**CORRESPONDENCE COVER SHEET
WASTE PERMITS DIVISION
TEXAS COMMISSION ON ENVIRONMENTAL QUALITY**

Facility Name: City of Victoria Landfill

Re: Response to Second Technical Notice of Deficiency (TCEQ Tracking No. 27435345)
City of Victoria Landfill (Type I)
Victoria, Victoria County, Texas
CN600243257/RN100212968
Proposed TCEQ Permit Number MSW-1522B
Major Amendment Permit Application

1522B PERMIT AMENDMENT			
DETAIL SHEET 4			
project	107608	contract	-
drawing	III.A1.19		rev. 2
sheet	21	of 25	sheets
file 107608III.A1.19.dwg

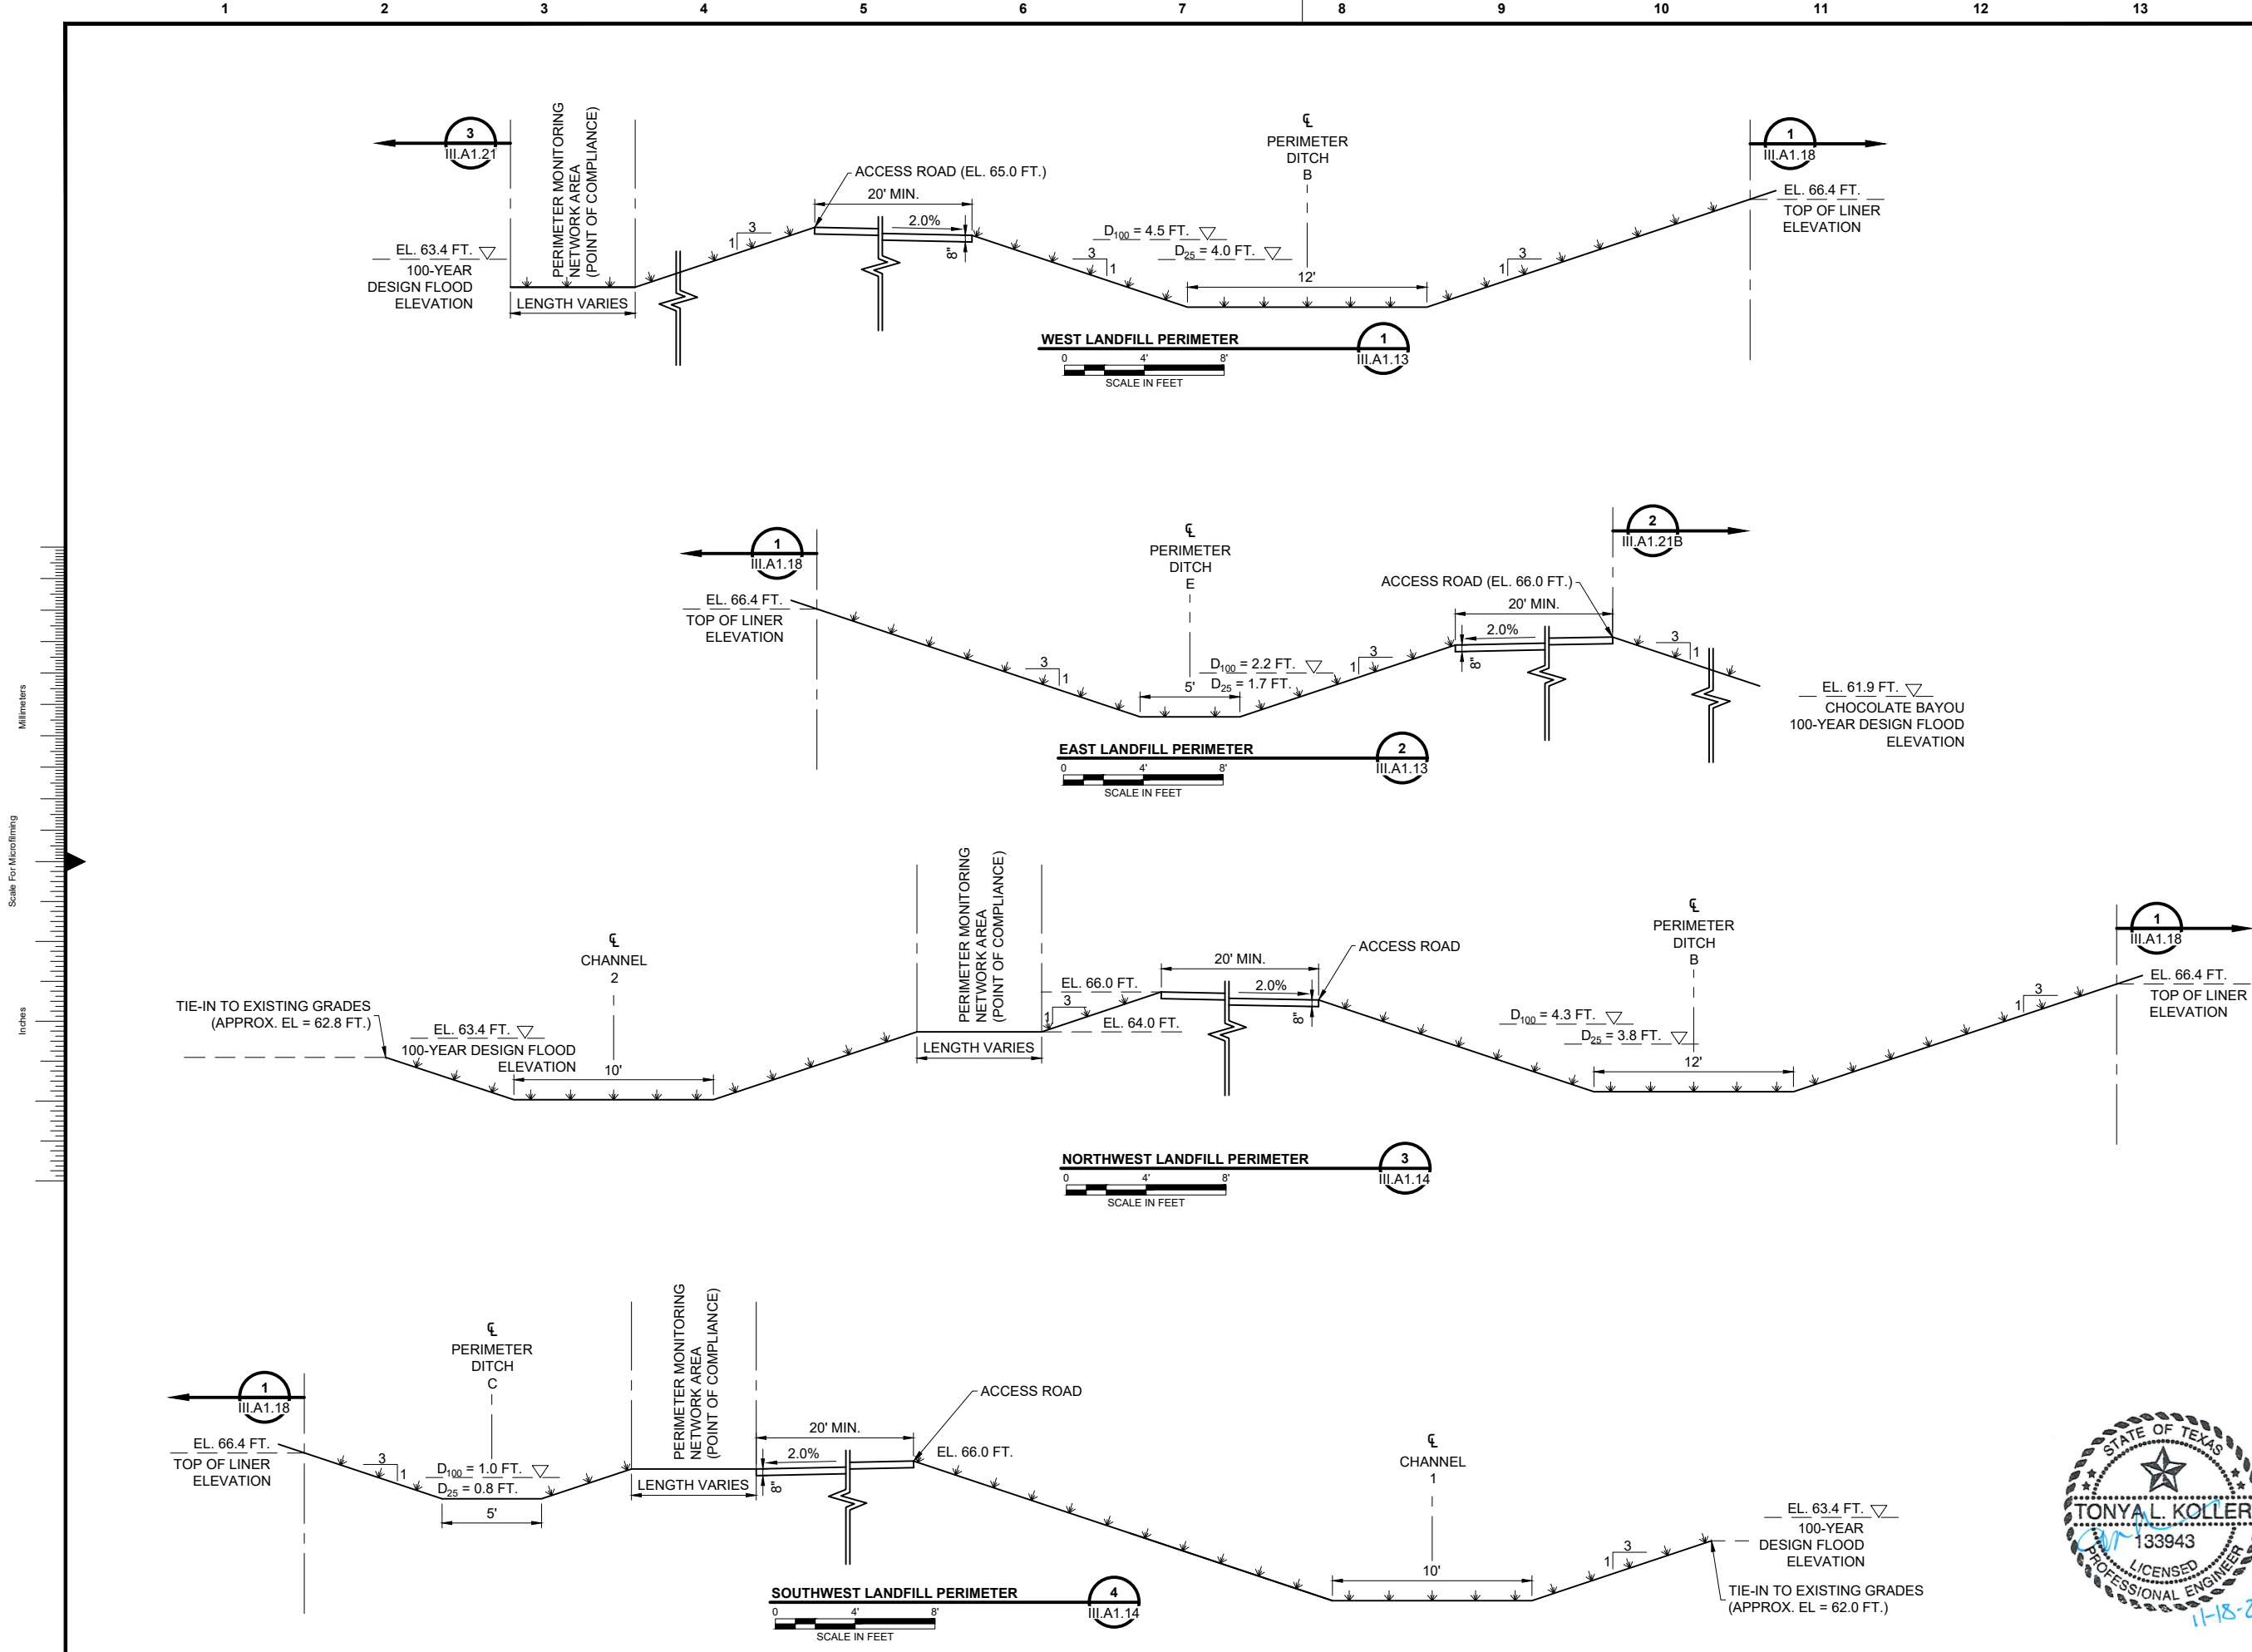
T10	<i>a. Revise the newly added Detail 4 on Drawing III.A1.19 to show a ridge between the Class 1 liner and the MSW liner, with the liners</i>	Detail 4 on Drawing III.A1.19 in Attachment III-1 has been revised to show the high-point of a ridge at the MSW-Class 1 liner division.
